Conceptual Zoning Site Plan

Cumberland Parkway Site - Cobb County, GA

PETITION NO.: Z-93

ZONING COMMENTS:

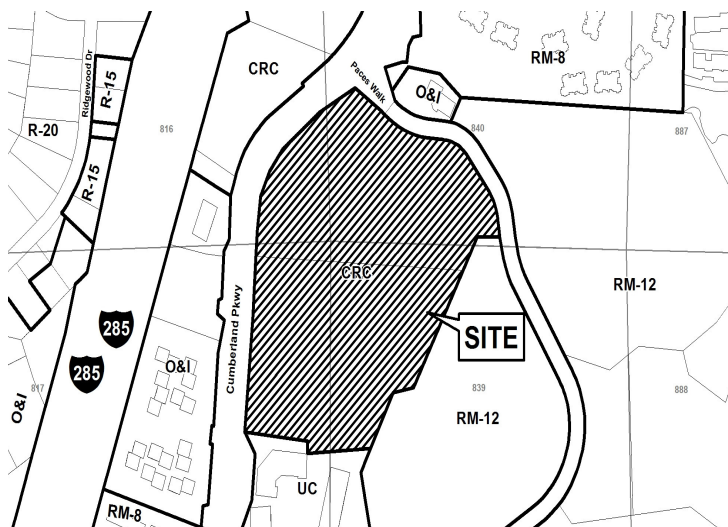
The proposed plan will require a contemporaneous variance to waive the front setback from the required 50 feet to 25 feet. The applicant also needs to reduce the 50-foot landscape buffer along the east and south property lines to allow the access drives.

- No Stormwater controls shown _____
- Copy of survey is not current – Additional comments may be forthcoming when current site conditions are exposed.
- No site improvements showing on exhibit.

Recommend a deceleration lane on Cumberland Parkway for the entrance.

Recommend applicant verify that minimum intersection sight distance of 490' is available for Cumberland Parkway entrance. Recommend restricting right turns on red if sight distance requirement can not be achieved at the signalized intersection.

Recommend signalized entrance directly align with the development across the street on Cumberland Parkway.

Based on the above analysis, Staff recommends **APPROVAL** for residential portion of the application and **DENIAL** of the commercial portion of the application subject to the following conditions:

1. Final site plan be approved by the Board of Commissioners;
2. Maximum of 16 units per acre;
3. Variances requested in Zoning Comments section;
4. Water and Sewer Division comments and recommendations;
5. Stormwater Management Division comments and recommendations; and
6. Department of Transportation comments and recommendations.
